**Presentation from
Paul Sedran, RESD Inc.**

**Bruce Power Mid-Term Update of
Licensed Activities**

Review of CNSC and Bruce Power Submissions on Elevated Heq in B6S13 for the Bruce Power Mid-term Review

P.J. Sedran, M.Eng, P. Eng.
Mech. Eng. Consultant

Expected Circumferential T & Predicted [D] Profiles
For the B6S13 Outlet RJ versus Measured [D] Profile

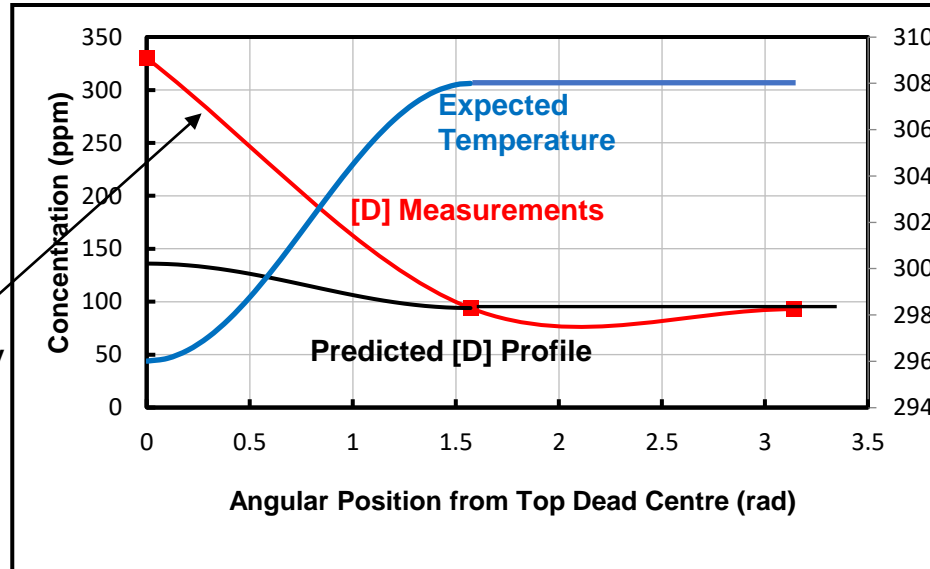
Measured [D] gradient is too steep to have been caused by the expected temperature profile

Concentration of Diffused D in the Elemental Volume vs θ

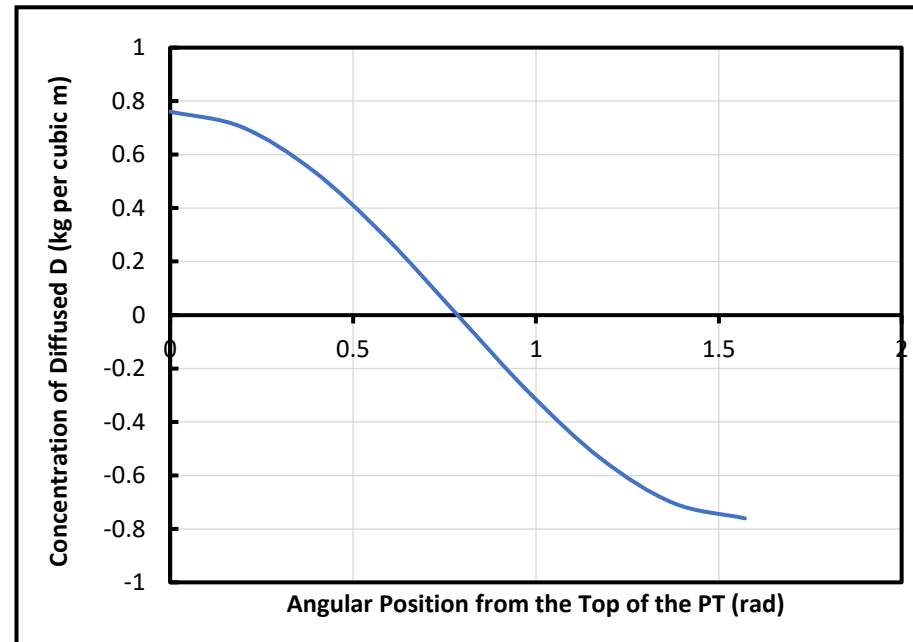
Since ① (2.043×10^{-8} kg) \approx ② (2.054×10^{-8} kg), then the circumferential D distribution for the B6S13 Outlet BM at 271279 HH is attributable to thermal diffusion based on Equation 5
